AS BUILT PLANS

CONCRETE FLUME DETAIL

THREADGILL - DOWDEY and ASSOCIATES
 CONSULTING ENGINEERS DALLAS, TEXAS
 DESIGN DRAWN CHECKED DATE SCALE JOB SHEET
 J.G.B. R.E. D.M.D. 9-80 1/2"=1'-0" 507-E 5/10

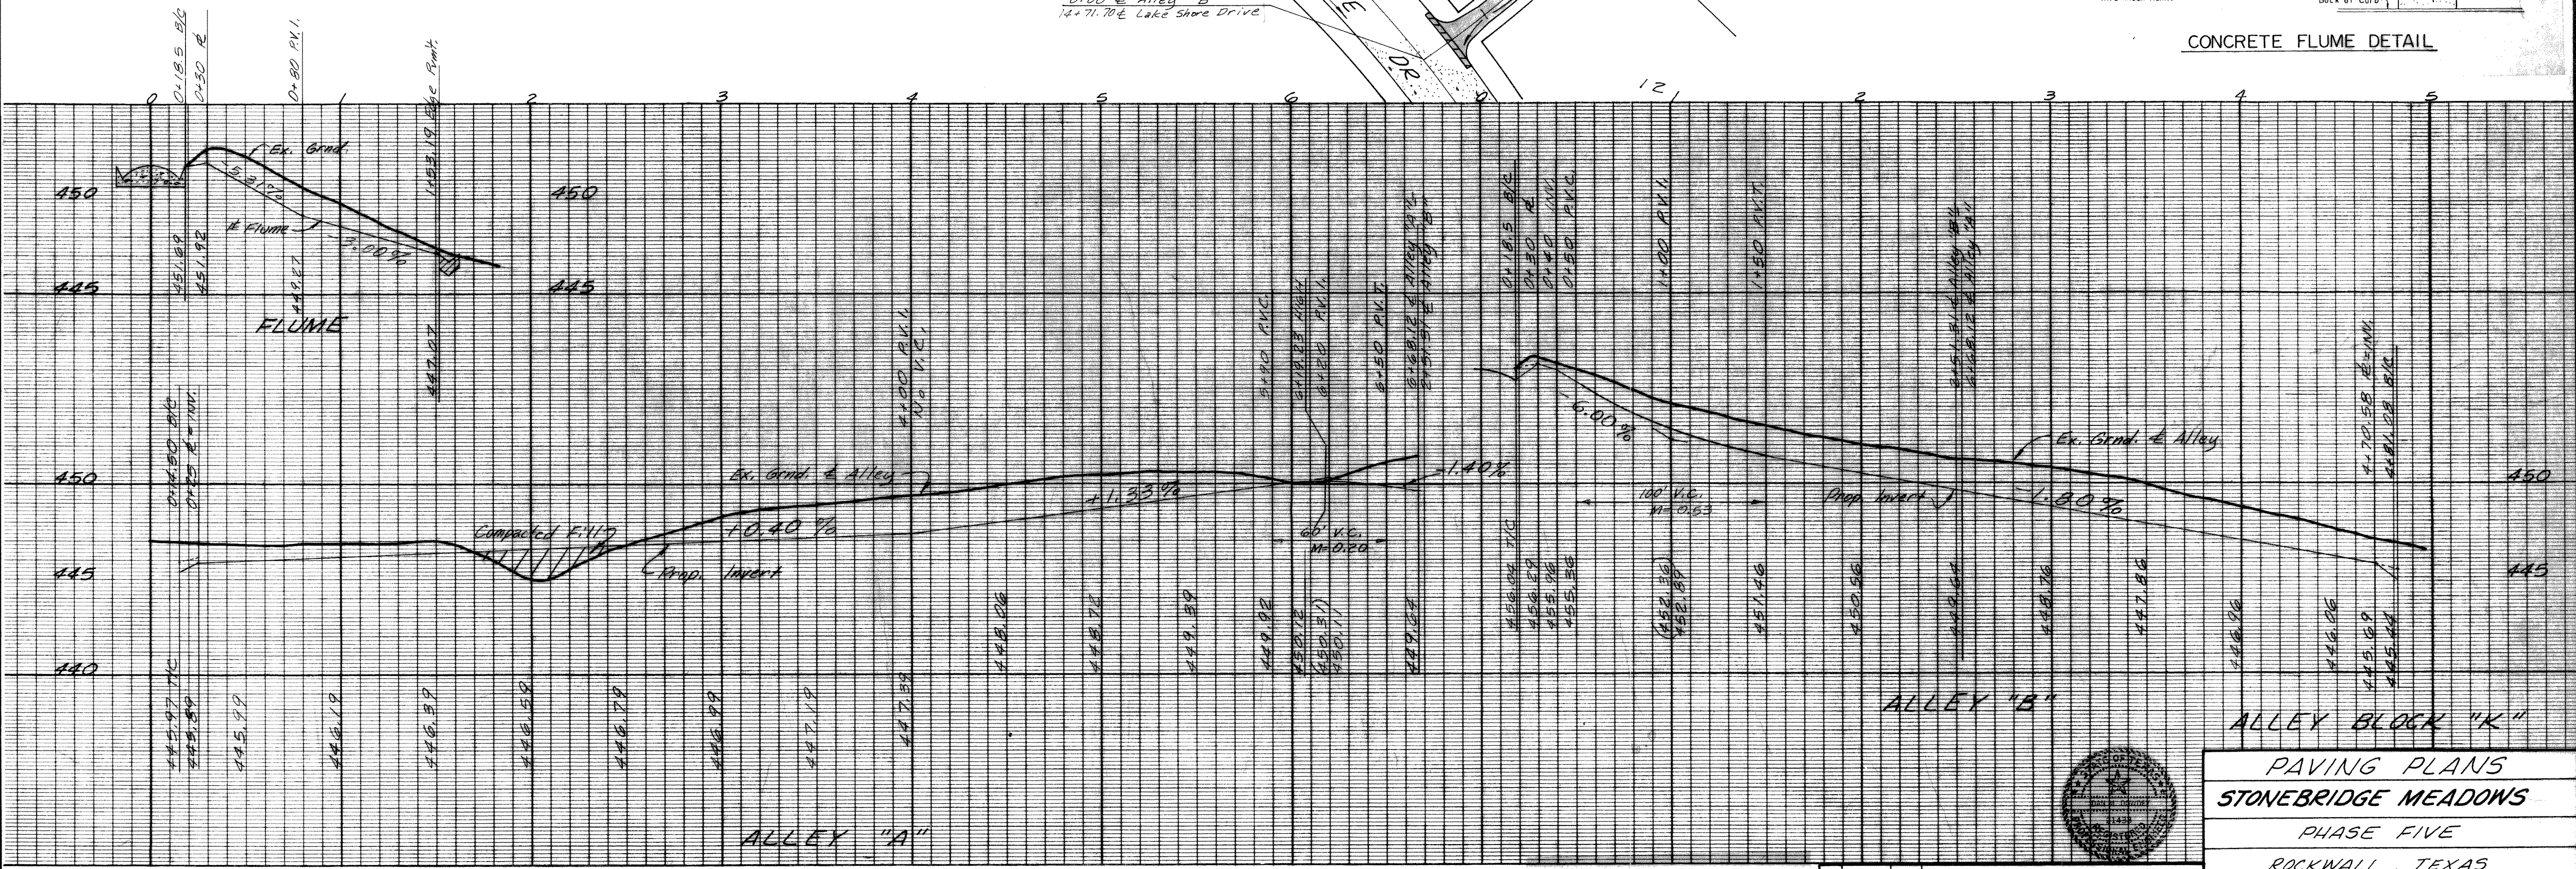
NO.	DATE	BY	REVISION
1	10-17-80	RE	Lowered Flume
